Azoteq Product Change Notice: (IQS525 & IQS572)

PCN Number: ACN_IQS525 IQS572_01

Table 2.1 IC Marking Update

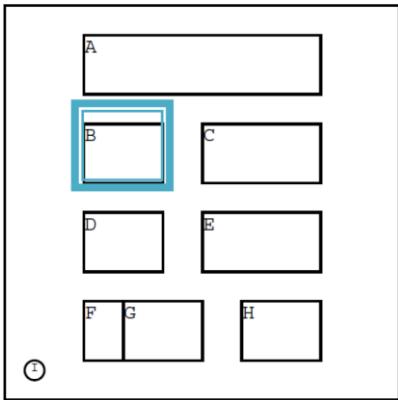
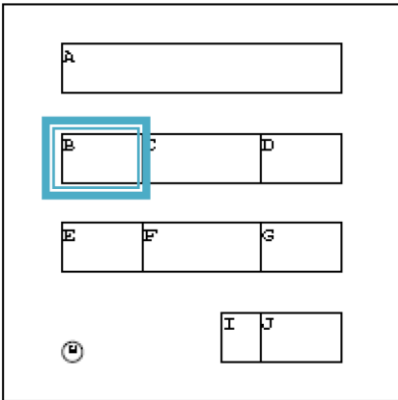
Traceability is maintained by means of an update to the IC marking.

From	To
Marking in B was 'GH'	Marking in B updated to 'GQ'
